Request for Additional Information No. 543, Supplement 2

U. S. EPR Standard Design Certification

**SRP Section: 14.03.08 - Radiation Protection Inspections, Tests, Analyses, and
Acceptance Criteria**

Question 14.03.08-5:**OPEN ITEM**

**Table 2.4.22-3—Radiation Monitoring System ITAAC
(32 Sheets)**

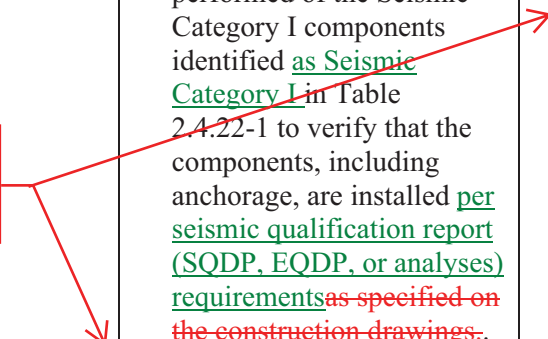
- d) FSAR Tier 1, Section 2.4.22, Table 2.4.22-3, Section 4.1, contains ITAAC indicating that tests will be performed on the RMS system to verify output signals. It is not clear whether these "tests" will include functional tests of the radiation detector, which is the essential component of the radiation monitoring channel. In the context of completing the ITAAC, the commitment described in FSAR Tier 1, Section 2.4.22, Item 4.2, should use the same type of radioactive calibration source's as are called for in FASR Tier 2, Rev. 1, Section 14.2.12.11.19 (Test #143) in demonstrating the operational function of the channel (while ensuring that the source does not present a hazard and doses are kept ALARA during testing). This approach would confirm that the radiation monitoring channel operates in accordance with design commitments. Please update Section 2.4.22 ITAAC to include information ensuring that the radiation monitors listed within Tier 1 will be tested to verify the appropriate response to high radiation levels after installation.

The inspections, tests, and analyses in U.S. EPR FSAR Tier 1, Table 2.4.22-3, will be revised to indicate that tests will be performed using an internal check source or a calibration check source with strengths at the lower level of monitor sensitivity to verify the appropriate response to high radiation levels. This is consistent with the description of the testing of the RMS provided in U.S. EPR FSAR Tier 2, Section 14.12.11.19 (Test #143).

4.1	The RMS provides the output signals <u>to the recipients</u> listed in Table 2.4.22-2.	<p><u>Tests will be performed using an internal check source, or a calibration check source with strengths at the lower level of monitor sensitivity, or test signals to verify the appropriate response over the design range of the RMS.</u></p> <p>Tests will be performed to verify the existence of output signals.</p>	The RMS provides output signals to the recipients listed in Table 2.4.22-2.

RAI 543,
Question
14.03.08-5(d)
